***Ampex******SLM Electronics*****#CSB0003****A Division of St. Louis Music, Inc****11880 Borman Dr****St. Louis, MO 63146****Phone 314 569 0141****Service Department****Phone 800 738 7563****Fax 314 567 7278**

November 6, 1997

**Customer Service Bulletin****Units Affected:**

## 07-319-xx AC Termination board as viewed from inside lower chassis

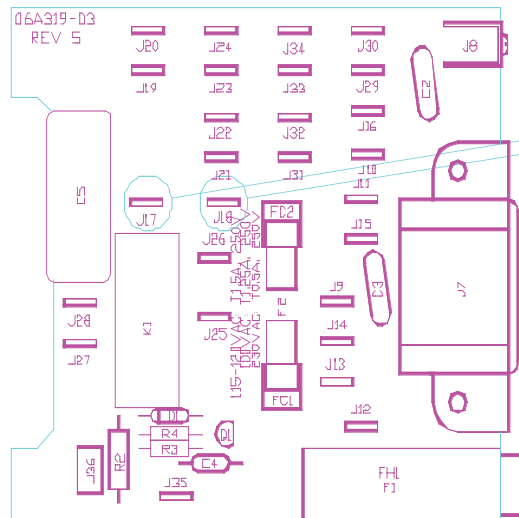
AC mains fuse for filament transformer would fail prematurely during normal operation when tuning unit on as a result of a design change to use IEC approved fuse beginning with 1/1/97 production. Replacement with larger value fuse would solve false tripping problem but would not always provide adequate protection against damage during severe fault condition.

Add two each 3A in-rush current limiters (ICL's) that have been prepared with .187" Fast-on connectors (SLME part number 97-123-23) to the filament transformer primary circuit as follows:

1. Disconnect the AC power from the unit.
2. Remove lower chassis assembly from cabinet and view from bottom.
3. On the 07-319-xx AC termination PC board, remove blue and gray leads from tabs J17 and J18.
4. Add one 97-123-23 ICL assembly in series with the blue transformer lead and tab J17, and one in series with the gray lead and J18 by attaching the female Fast-on connector of ICL to the tab on the printed circuit board and the male Fast-on to transformer lead.
5. Secure the assembly with a cable tie to other AC wires so that no leads are touching other parts.
6. Replace the fuse (F2) with a T1.25A (SLME part number 23-512-05).
7. Remove any fuse label so that "100VAC T1.25A" is visible on the printed circuit board.
8. Reassemble and check out unit for proper operation.

Add one 97-123-23 ICL assembly in series with J17 and the blue transformer lead and one in series with J18 and the gray transformer lead.
